NEW FIRE ALARM SYSTEM FOR JAMES F. BYRNES BUILDING

USC PROJECT NO: H27-I851-A JCS PROJECT NO: 11104

ADDENDUM 01 June 1, 2012

ELECTRICAL ITEMS - ADDENDUM NO. 1 June 1, 2012

FIRE ALARM SYMBOLS, DETAILS, RISER AND NOTES

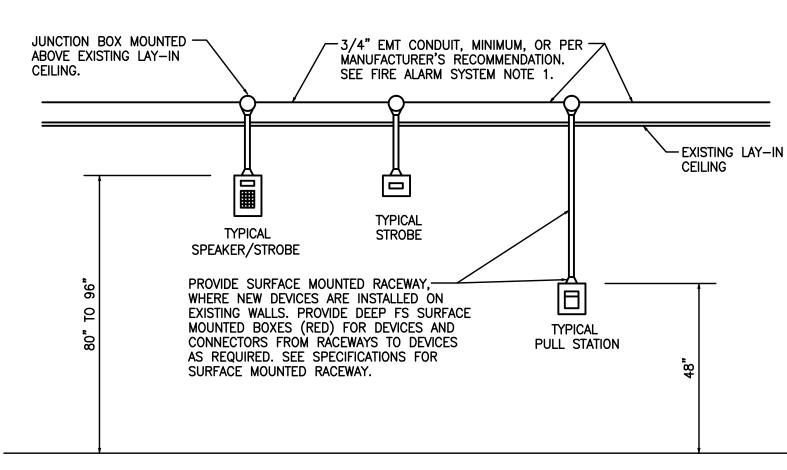
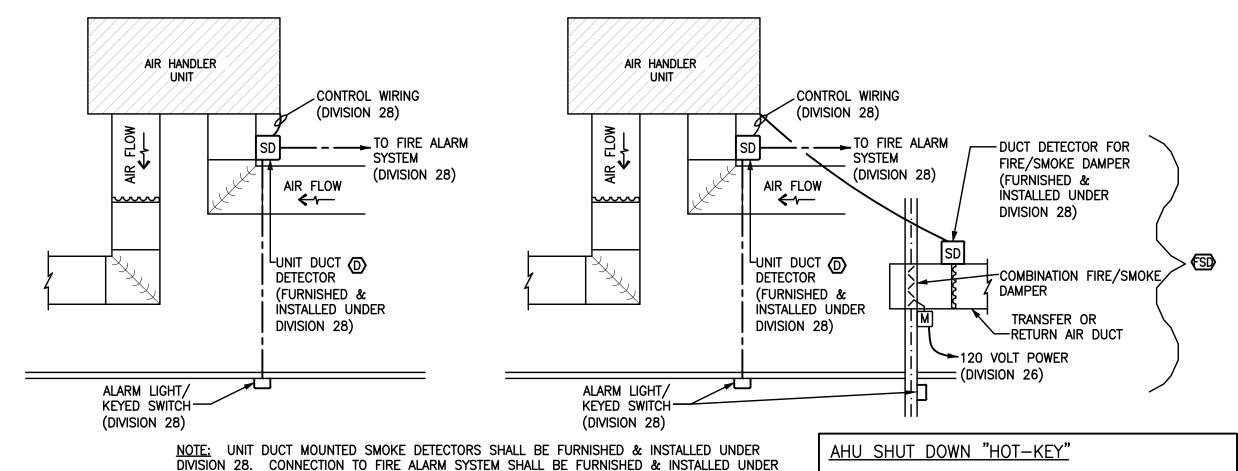
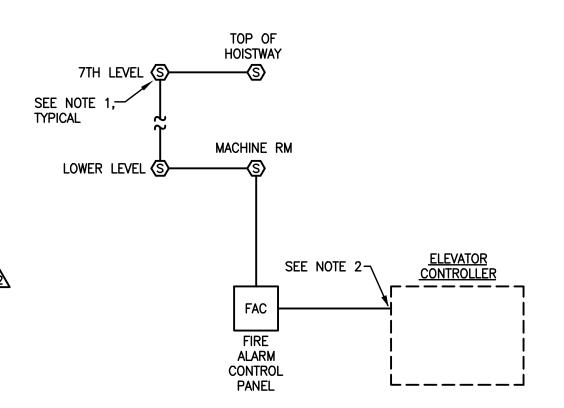
2. **SHEET E001**:

See attached drawing for Revision 2, dated 5/31/12 for addition of Mass Communication requirements and installations.
